Mangoola Coal Continued Operations Major Project

Critical Review of the Assessment of Impacts to Terrestrial Ecology

December 2020

Prepared by Ziggy Andersons for Muswellbrook Shire Council

Figure 1: BAR Figure 2.3 – Targeted Species-credit Flora Transect Location

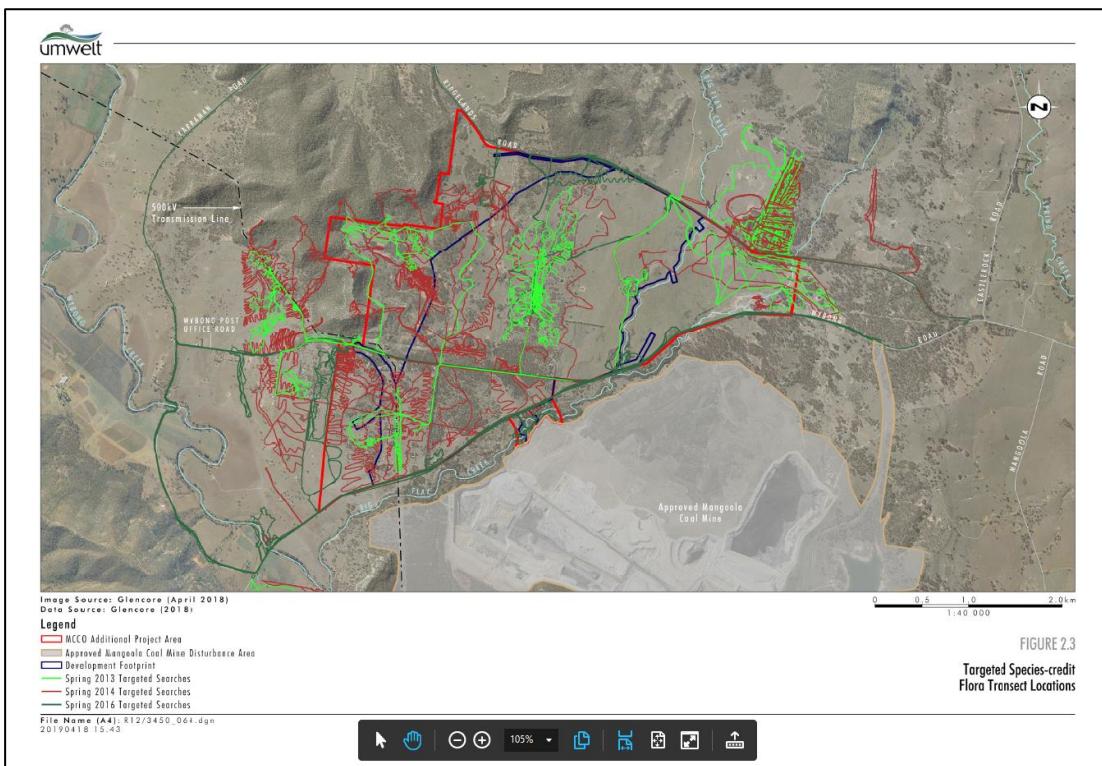
26. With the BAR being dated June 2019, the threatened flora surveys undertaken in 'Spring' 2013 (yellow lines on Figure 2.3 of the BAR) are unable to be used to satisfy survey effort requirements as per The NSW Guide to Surveying Threatened Plants (OEH 2016).

27. As indicated in Figure 2.3 of the BAR, the threatened species surveys within the Development Footprint were undertaken by way of random meander and therefore were conducted inconsistent with the relevant guideline.

28. The survey effort for threatened flora may appear substantial as presented by Umwelt in Figure 2.3 of the BAR (**Figure 1**). However, if one excludes the 2013 surveys due to their age and the survey effort outside of the Development Footprint and instead concentrate on the area covered within the Development Footprint (the dark blue polygon in Figure 2.3 of Appendix 13 BAR) (**Figure 1**) the effort applied was far from a comprehensive survey for threatened flora. Therefore, the Applicant's Consultant's assessment of the impact of the proposed project on threatened flora is not consistent with the relevant guidelines.

Figure 2: Cropped extract from Figure 2.3 of the MCCO Project BAR

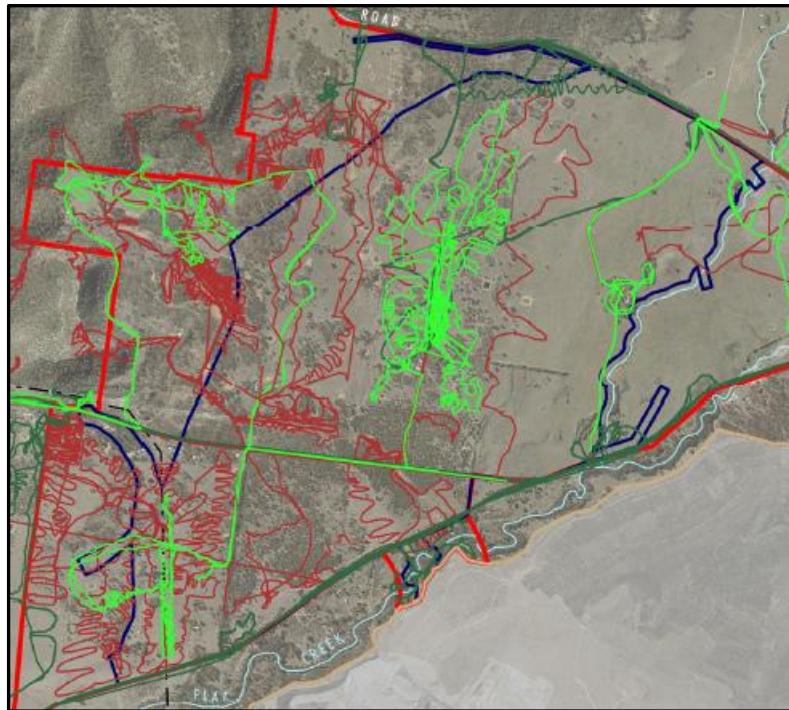
33. When extrapolating the survey effort graphically displayed in the cropped extract from Figure 2.3 of the BAR (**Figure 2**) over Figure 18 of the Expert Report (Bell 2019) (**Figure 3**), it is clear that the Applicant has applied insufficient survey effort within potential *Diuris tricolor* and *Prasophyllum petilum* habitat.

Figure 3: Figure 18 of the Expert Report (Bell 2019)

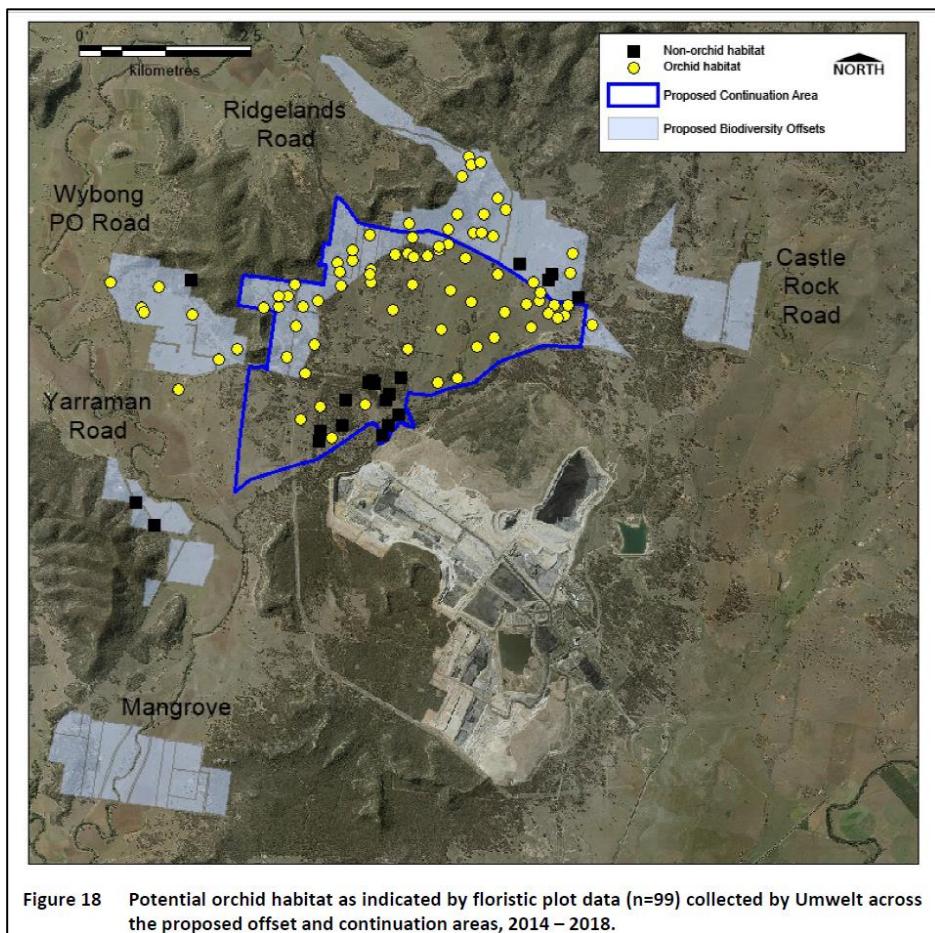
32. Figure 18 of the Expert Report (Bell 2019) (**Figure 3**) is a graphic depiction of how much of the Development Footprint the Applicant's Expert determined as being 'potential orchid habitat'. In addition, the '*BCD regards vegetation zones 1 to 9 as known or potential habitat within the proposed impact area, totalling 567.81 hectares*' (BCD 2019). The TBPDC identifies PCT 1603 as being potential habitat for *Prasophyllum petilum* and *Diuris tricolor*, 492.74 hectares of this PCT occur within the Development Footprint (DPIE 2020).

34. Figure 18 of the Expert Report (Bell 2019) (**Figure 3**) identifies (as black squares) the woodland area adjacent to the existing Mangoola Mine as being Non-Orchid Habitat. However, there are numerous records for both orchid species within this locality, with Applicants Consultant identifying this same habitat as containing a population of *Prasophyllum petilum* (Figure 3.7 of BAR).

Figure 4: Figure 3.7 of the BAR.

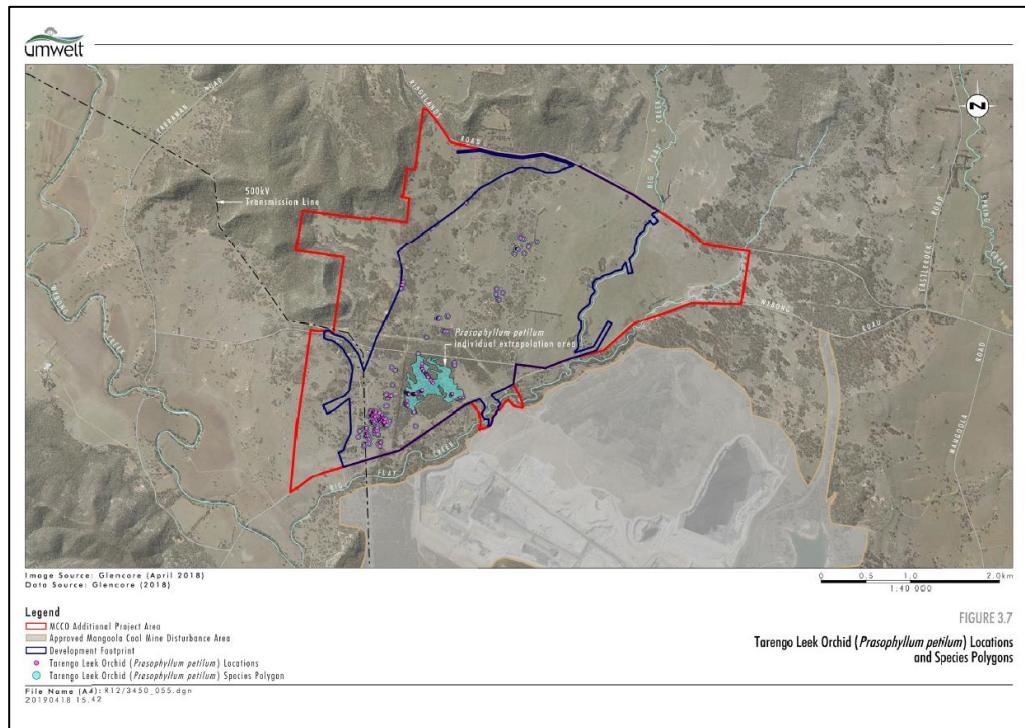
42. Based on the information provided by the Applicant's Consultant the *Prasophyllum petilum* Individual Extrapolation Area polygon does not align with any vegetation type boundaries or abiotic boundaries. Nor is any justification provided within the BAR for the location and extent of the Individual Extrapolation Area polygon which the Applicant's Consultant describes as 'potential habitat area' (3.3.2 BAR).

45. The BAR states that '*the species polygon is shown for presentation purposes and does not reflect an area of habitat*' (3.3.2.1 BAR) which is a direct contradiction to the fact that the Applicant's Consultant identified the entire 13 ha polygon as containing four individuals per hectare.

47. The minimal survey effort that was undertaken within the *Prasophyllum petilum* Individual Extrapolation Area (Figure 3.7 BAR) (**Figure 5**) indicates significantly higher densities than four individuals per hectare. However, the data used to extrapolate the population size was not provided, in particular the number of individuals recorded along the 'transect' and the area that was covered by the 'transect'.

Figure 5: Cropped extract of Figure 3.7 of the BAR overlaid by cropped extract of Figure 2.3 of the BAR (Umwelt 2019a)

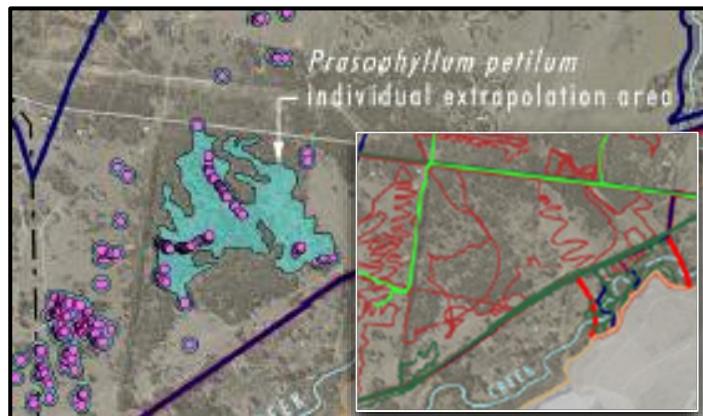
48. As stated in the Expert Report '*Prasophyllum detection is considerably more difficult than Diuris due to the small stature and insignificant flowers of this species when compared to Diuris, and consequently I suspect that many *Prasophyllum* individuals were overlooked during these targeted surveys (2010-2015)*' (Bell 2019). Therefore, based on the single 'transect' that was undertaken, the predicted density cannot be considered an accurate reflection of the number of individuals within this location.

- 50. Therefore, the approach taken by the Applicant's Consultant in extrapolating the density of *Prasophyllum petilum* within the Tarengo Leek Orchid (*Prasophyllum petilum*) Species Polygon (Figure 3.7 of the BAR) (**Figure 4**) is inconsistent with *The NSW Guide to Surveying Threatened Plants* (OEH 2016). This is due to the inappropriate survey method and limited effort applied, the confidence not being detailed as per the requirements of *The NSW Guide to Surveying Threatened Plants* (OEH 2016), and the extent of the Tarengo Leek Orchid (*Prasophyllum petilum*) Species Polygon not being adequately justified.
- 51. Therefore, the BAR provides an inaccurate assessment of the number of individuals and the MCCO project would likely result in a greater impact than has been represented by the applicant or assessed by the regulator.

Figure 6: Figure 9 of the Expert report (Bell 2019)

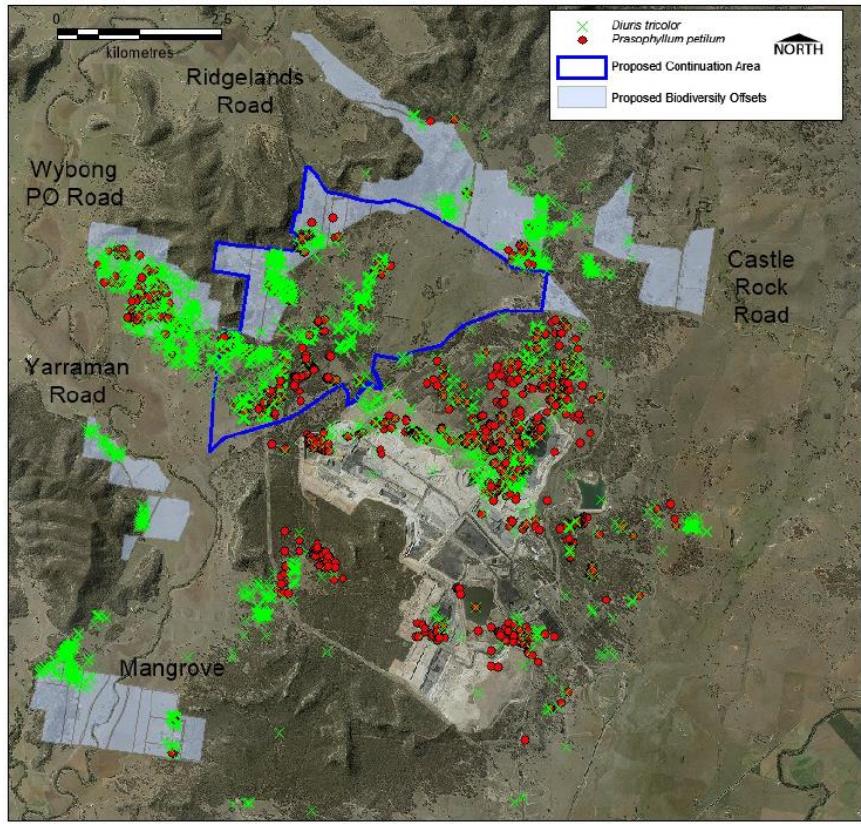
- d. Figure 9 of the Expert report (Bell 2019) (**Figure 6**) displays the records of *Diuris tricolor* and *Prasophyllum petilum* based on surveys between 2009 and 2017 further indicating that considerably more than 2 individuals of *Diuris tricolor* are/were present within the existing Mangoola Coal Project Development Footprint.

59. Therefore, it is unclear what number of *Diuris tricolor* and *Prasophyllum petilum* have and will be impacted upon by the existing Mangoola Coal Project and the proposed MCCO Project were it to be approved.
